31/07-06I 10245 Capitol Veiw Avenue
Kensington Historic District, 31/06

HISTORIC PRESERVATION COMMISSION STAFF REPORT

Address: 10245 Capitol View Ave, Silver Spring **Meting Date:** 05/10/06
Resource: Outstanding Resource **Report Date:** 05/03/06
 Capitol View Park Historic District
Review: HAWP **Public Notice:** 04/26/06
Case Number: 31/07-06I **ax Credit:** N/A
Applicant: Carl Mahany **Staff:** Michele Oaks
 (Tom Manion, Architect)

PROPOSAL: Construct two, new houses on the newly subdivided Lots 1 and 2.

HOUSE B - FRONT ELEVATION

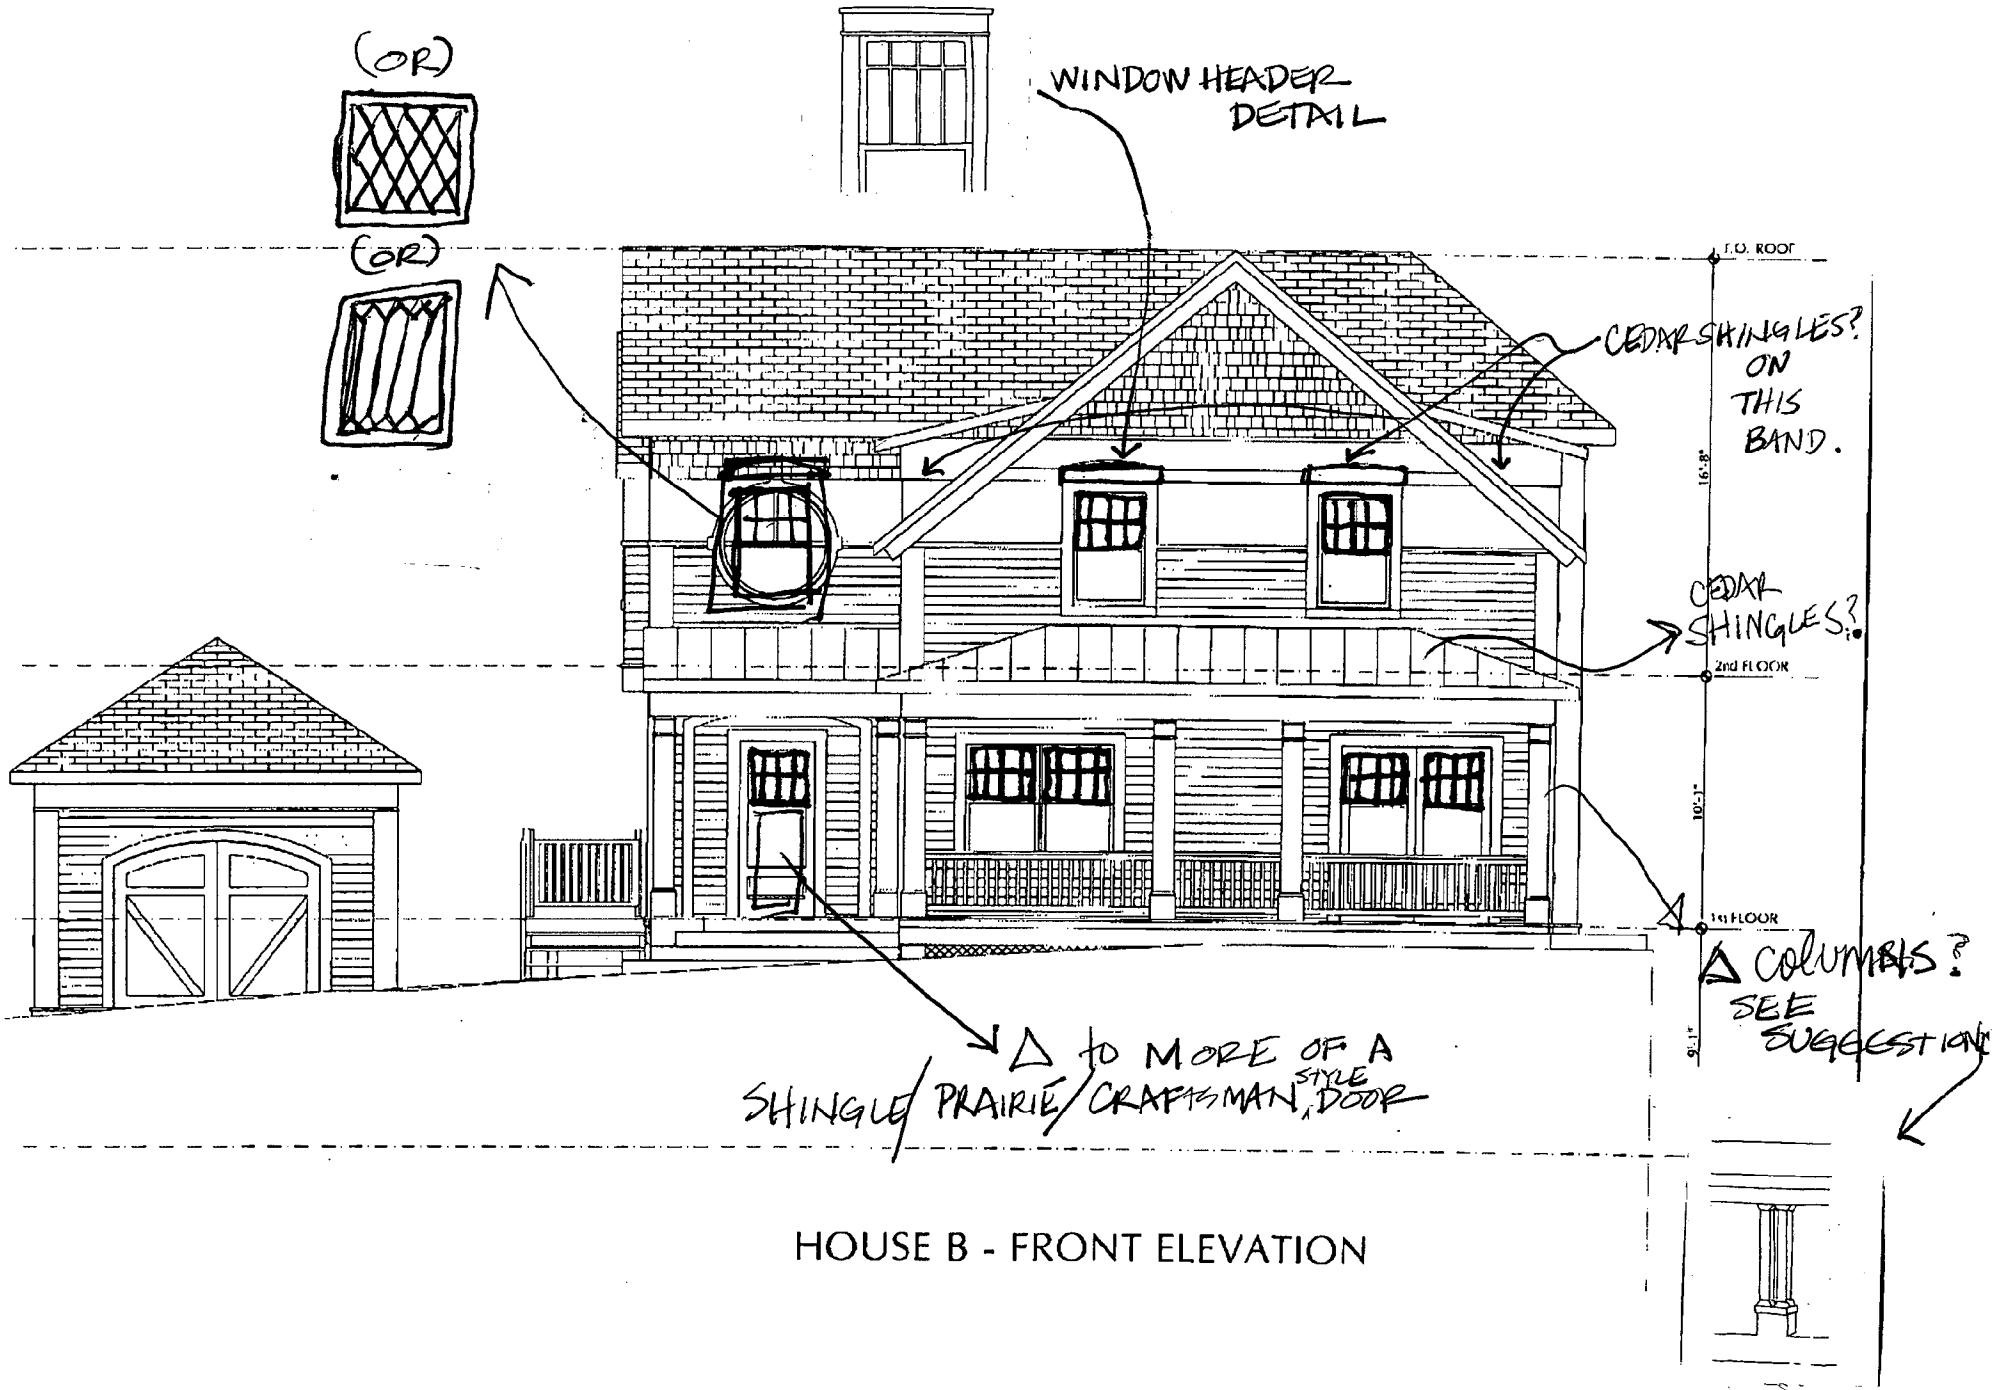
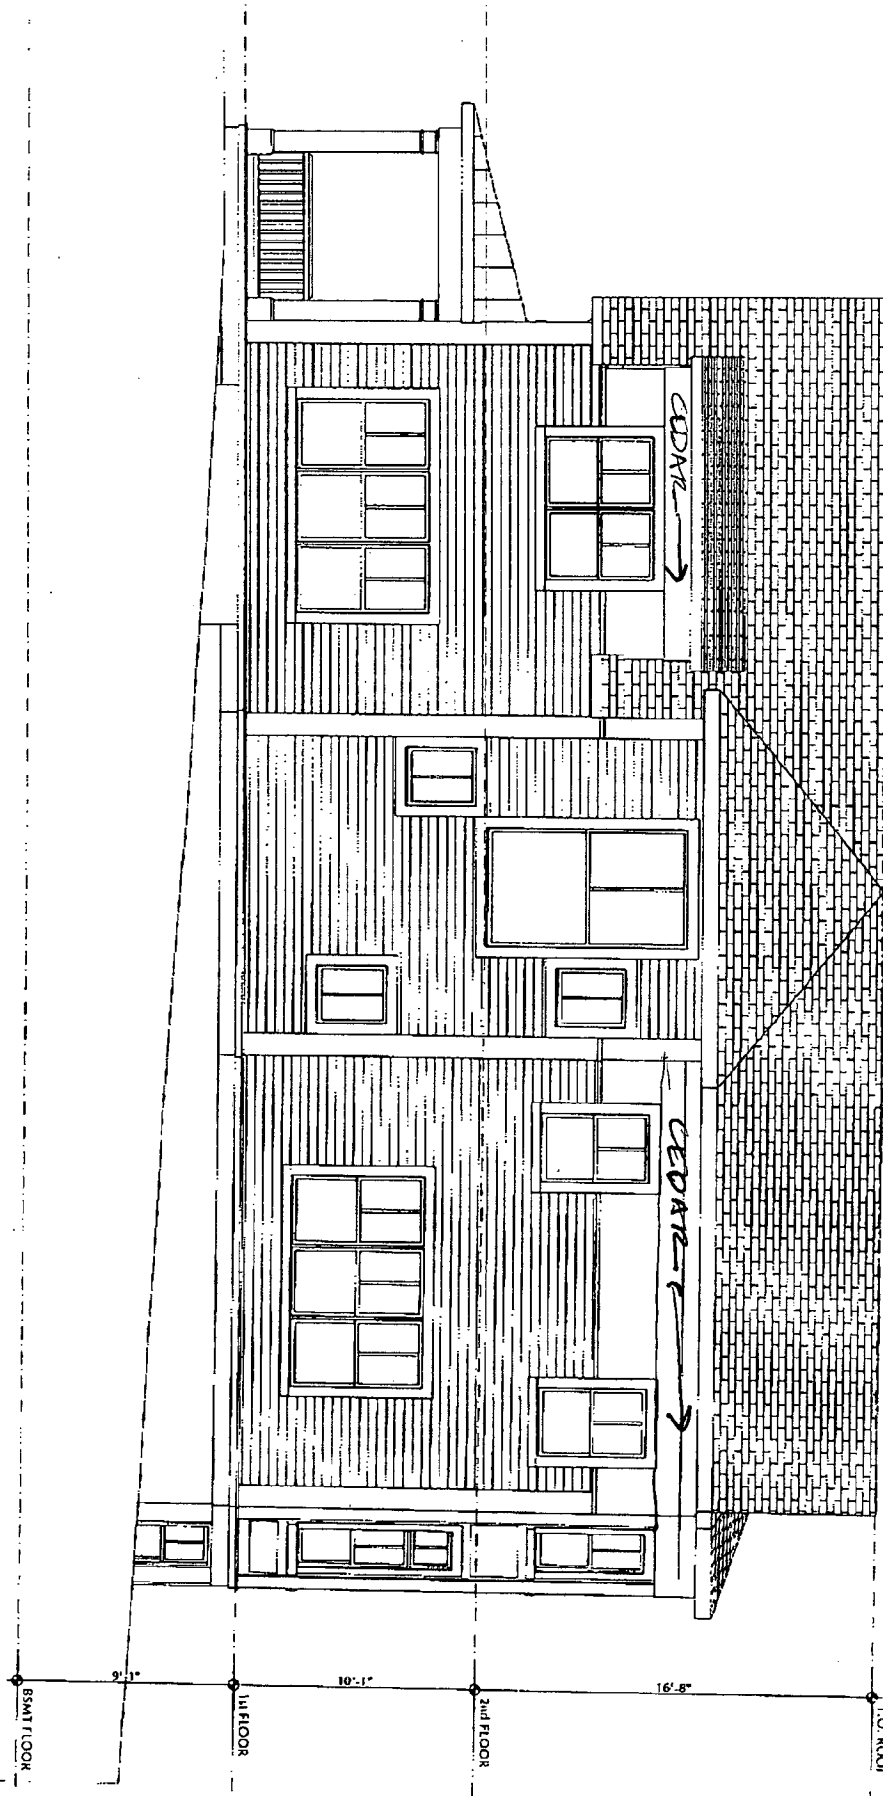
Message / Comments: Michele, Here are some revised elevations putting the shingles back into the gables instead of the board & batten. Give me a call to discuss or if you have any questions. Thanks, Kathy
